TOWN OF EAGLE REFERRAL RESPONSE SUMMARY REPORT

ISSUED: August 13, 2025

Project Name: Vail Valley Design Center Development Plan and Lot Consolidation (DR25-04 & LLA25-02)

Prepared by: Alyssa Rivas, Planner – Community Development Department

1215 CHAMBERS AVE.
STORAGE FACILITY
EAGLE, CO
UTILITY PLAN

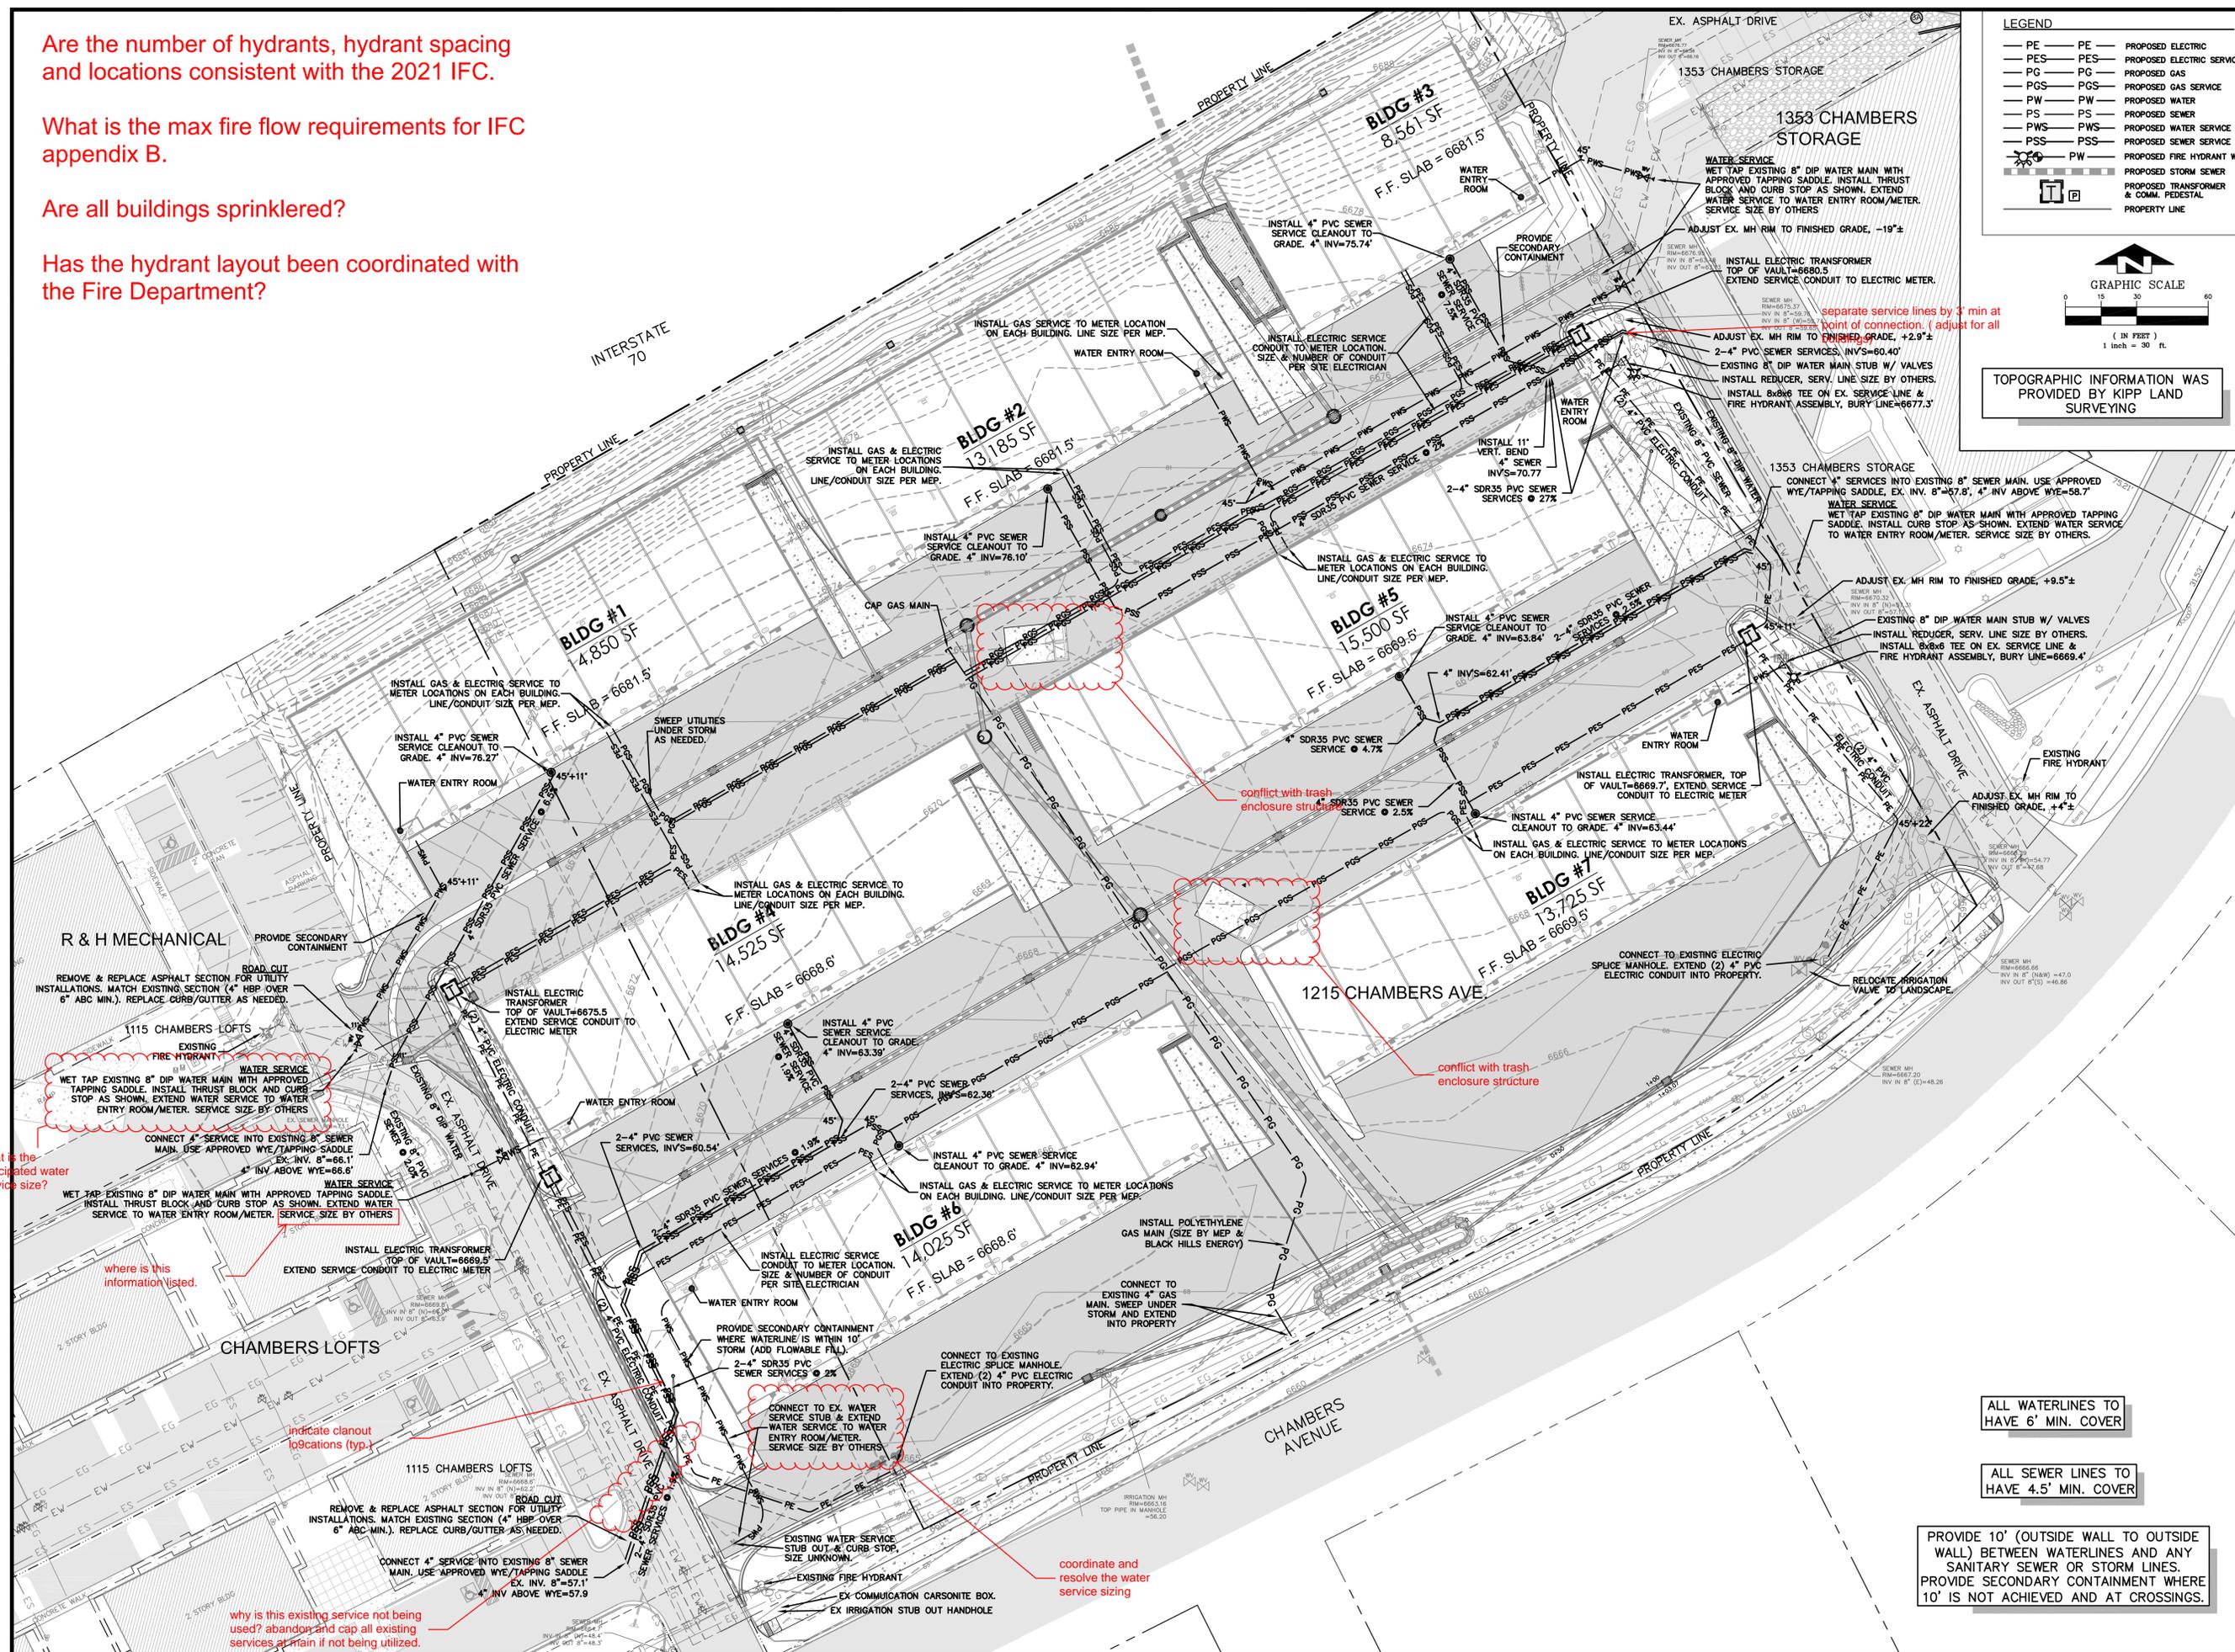
what is the anticipated water service size?
